Oregon State University
Construction Contract Administration
DIXON RECREATION RENOVATION

ADDENDUM NO. 2

Addendum #2

Project: Oregon State University
Dixon Recreation Center Renovation
425 SW 26th Street
Corvallis, OR 97331

1 ENLARGED FLOOR PLAN - RACQUETBALL COURTS LEVEL 1 - ELECTRICAL NEW
E1.11 SCALE: 1/4" = 1'-0"

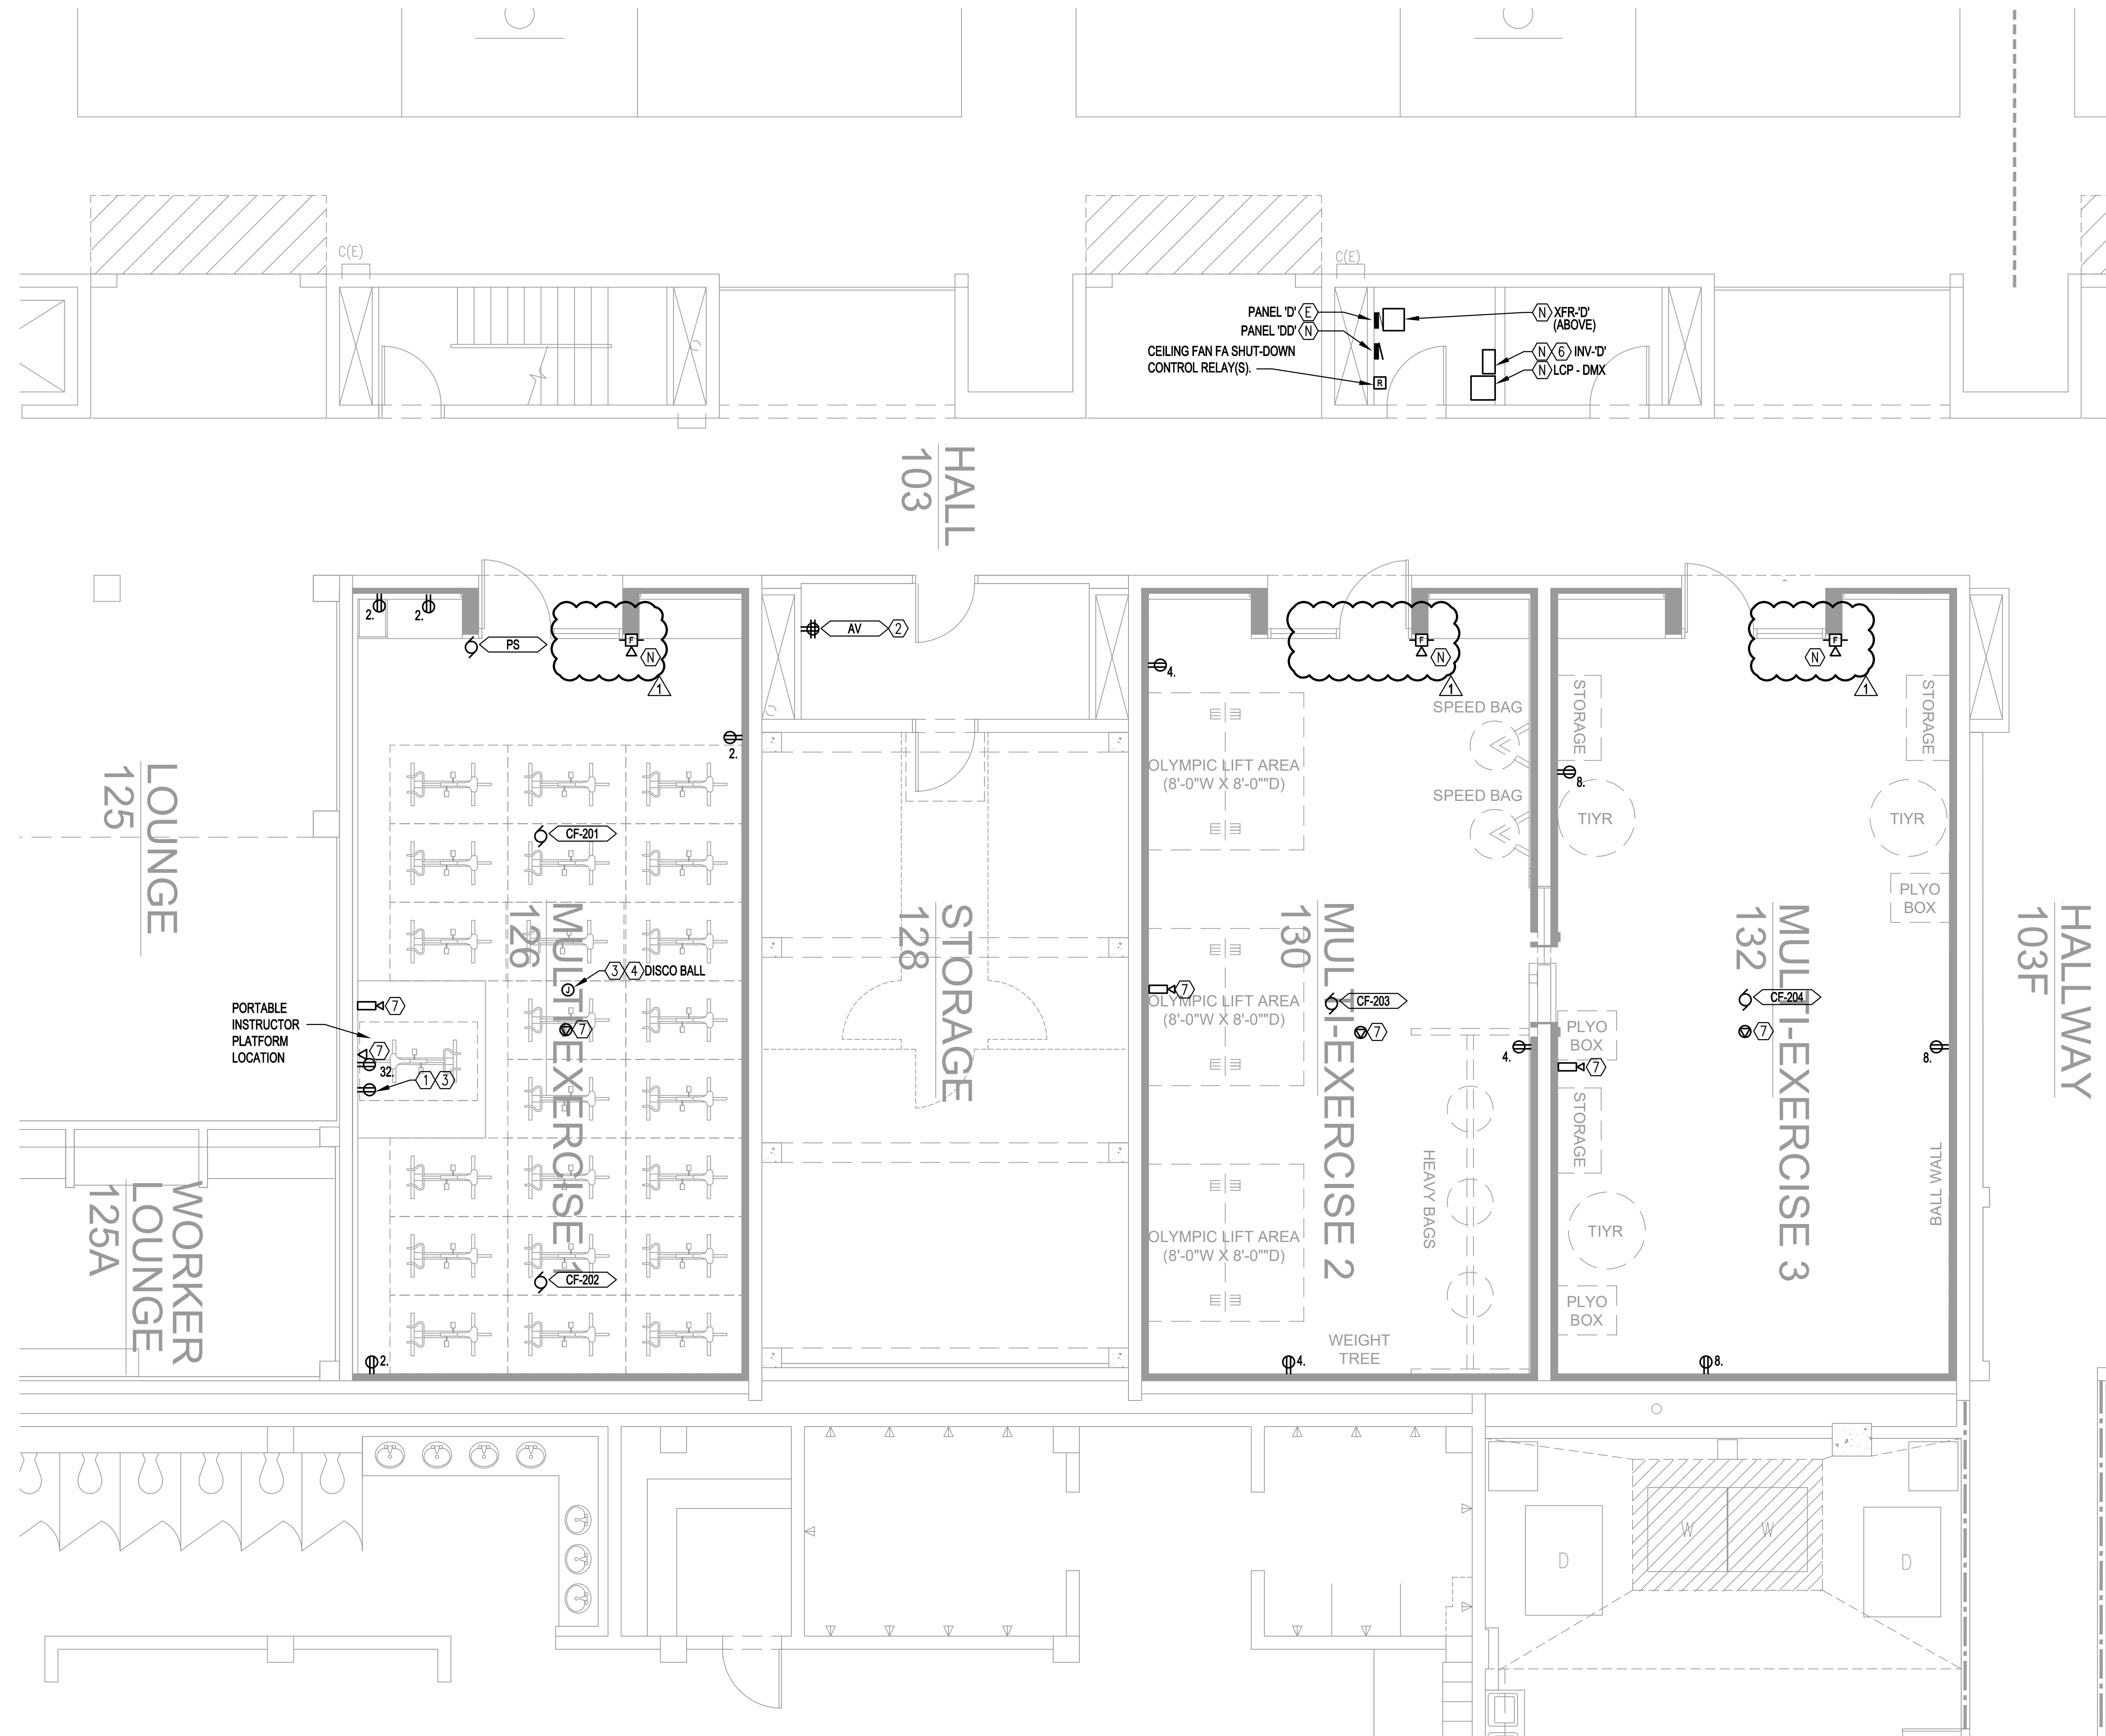
1. In response to contactor bid questions regarding the Fire Alarm devices at the new Multi-Exercise Rooms, sheet E1.11 has been updated. Revisions include add of (3) new Fire Alarm horn/strobe devices in lieu of relocating existing devices and Revise location for (3) Fire Alarm horn/strobe devices on plan.

10	Reference Sheet E1.11 – The (3) FA horn/strobes (same as Item #8 above) are shown to be located in the glass side lites in the new spaces. These locations will not work. Please clarify/provide a new location for the horn/strobes.	Response: Location to be revised. See Addendum #2, drawing E1.11.
11	Reference Sheet E1.10 – There is a relocated fire alarm annunciator panel shown in Waiting 107A. However, there is no key note or scope of work provided. Please clarify if this fire alarm annunciator is relocated under this project, provide a scope of work, provide the existing location, and/or clarify all work involved with this fire alarm annunciator.	Response: Existing location of Fire Alarm Annunciator Panel (FAAP) is shown on ED1.10. As indicated on ED1.10, keyed note #6 the FAAP is to be relocated to new location shown on E1.10 under the scope of this project. Existing wall where FAAP is to be relocated is to have drywall removed and framing modified as required for new location.
